Subject: Almond 2 Power Plant (09-AFC-02)  
Comments on CEC Staff Assessment

FOR  
**TID Almond 2  
Power Plant**  
(09-AFC-02)

**Comments on the CEC Staff Assessment**

**FIGURE 1.1-3R**  
**SITE LOCATION**  
ALMOND 2 POWER PLANT  
CERES, CALIFORNIA

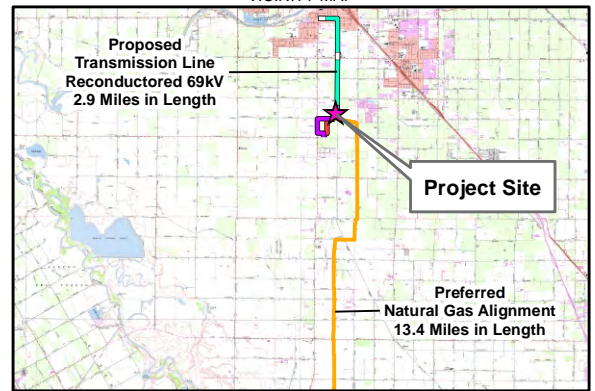
As a result of these advanced discussions, TID has determined that it would be beneficial to increase the size of the laydown area to approximately 6.4 acres for temporary, construction-related activities. This additional area will be adjacent to the western border of the proposed A2PP site within the WinCo property, on land that was historically used for agriculture (see Figure 1.1-3R).

Figures 1.1-3R and 2 show the location of the 6.4-acre laydown area, which will serve as a staging area during construction of the A2PP. (All figures are provided at the end of this report.) The laydown area will be adjacent to the western border of the proposed A2PP site within the WinCo, on land that was historically used for agriculture. Recently, the area has been used by WinCo as a laydown area, borrow pit, and stormwater pond for the WinCo distribution center to the west of the A2PP. A stormwater pipe in the northwest corner of the laydown area will be relocated to drain directly into the WinCo stormwater pond. The additional laydown area contains sufficient room to allow TID can forgo the use of the originally proposed 1.85-acre laydown to the north of the A2PP site. Figure 1.1.-3R has been updated to reflect the additional laydown area.
